Sérial: NPD-NRC-2009-134  
July 1, 2009

**LEVY COUNTY NUCLEAR POWER PLANT, UNITS 1 AND 2  
DOCKET NOS. 52-029 AND 52-030  
RESPONSE TO REQUEST FOR ADDITIONAL INFORMATION LETTER NO. 034 RELATED TO  
BASIC GEOLOGIC AND SEISMIC INFORMATION**

**Levy Nuclear Power Plant Units 1 and 2  
Response to NRC Request for Additional Information Letter No. 034 Related to  
SRP Section 2.5.1 for the Combined License Application, dated May 8, 2009**

Progress Energy Florida  
**Levy Nuclear Plant  
 Units 1 and 2  
 Part 2, Final Safety Analysis Report**  
 Site Vicinity Geologic Map  
 (40-km [25-mi.] and 8-km [5-mi.] Radius)  
 Figure 2.5.1-244 (Revised)

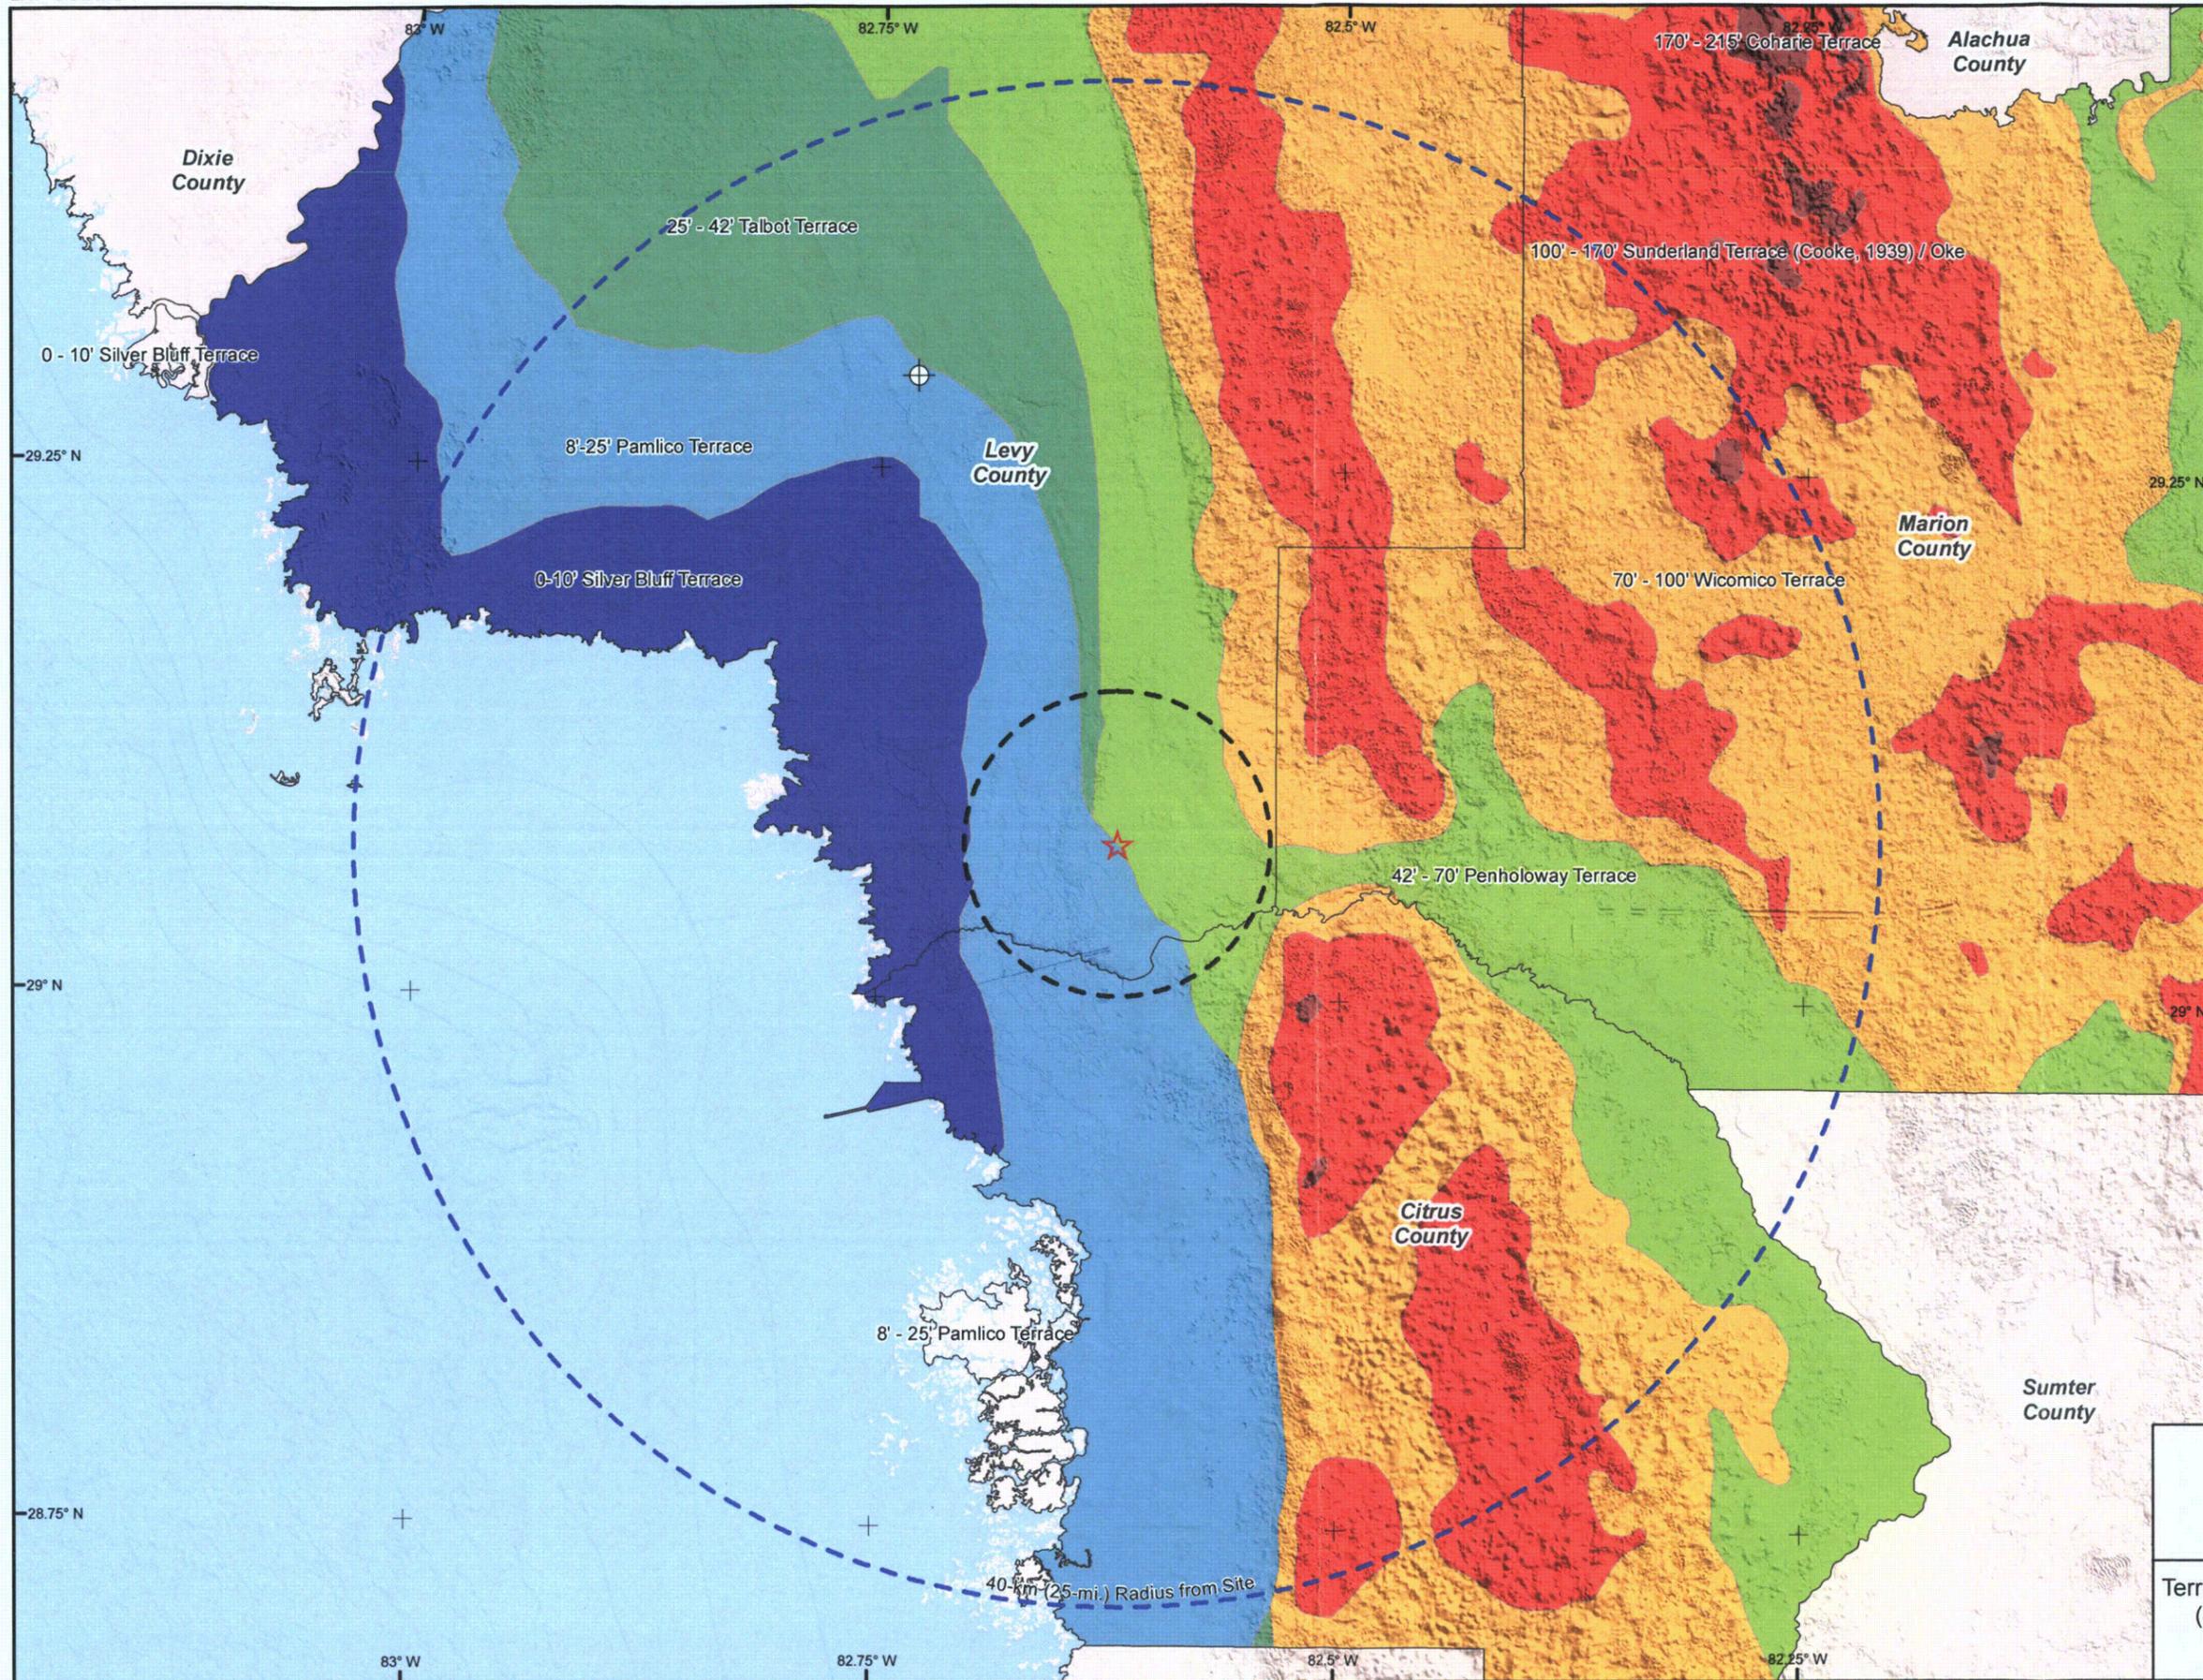
FSAR Section 2.5.1.2.3 (pg 66) references FSAR Figure 2.5.1-244 which presents a site vicinity geologic map. The legend on this figure does not show the correct sequence of stratigraphic units, commonly presented with oldest at the bottom of the legend to youngest at the top, to enable interpretation of the correct stratigraphic sequence. In addition, this site vicinity geologic map appears to be based on the 1:1,000,000-scale geologic map of Florida prepared by Scott and others (2001) which may lack sufficient detail to properly portray geologic structures and stratigraphy at the scale of the site vicinity.

Figure 2.5.1-244 also shows the locations of three drillholes (W-7534, W-7538, and W-7453) which are not presented in cross sections in the FSAR. These data are potentially useful for helping to assess the presence of faults such as those proposed by Vernon (1951). The drill holes presented in the cross section shown in FSAR Figure 2.5.1-245 are not located on the geologic map of Figure 2.5.1-244.

In order for the staff to understand the stratigraphic sequence and assess all existing information regarding subsurface geology and potential structures in the site vicinity, please correct the legend of Figure 2.5.1-244 to show stratigraphic sequence from oldest at the bottom of the legend to youngest at the top since that is the standard way of presenting such geologic data. Please also justify the use of a 1:1,000,000-scale geologic map to illustrate structure and stratigraphy at the site vicinity scale. In addition, please locate drill holes W-7534, W-7538, and W-7453 on Figure 2.5.1-244 and present drillhole data in a cross section to enable assessment of the presence of faults such as those proposed by Vernon (1951).

The legend of Revised Figure 2.5.1-244 will be modified in a future revision to show stratigraphic units in the correct stratigraphic order. Drill holes W-14519, W-15075, W-6903, W-15643, and W-8883 which are shown in the cross section on Figure 2.5.1-245 will be added to Revised Figure 2.5.1-244 in a future revision. The projected locations of drillholes W-7534, W-7538, and W-7453 will be shown on Revised Figure 2.5.1-245. A cross section across postulated Vernon (Reference 2.5.1-262) faults that incorporates available data from these wells (primarily velocity profiles) will be provided in response to RAI 02.05.01-19.
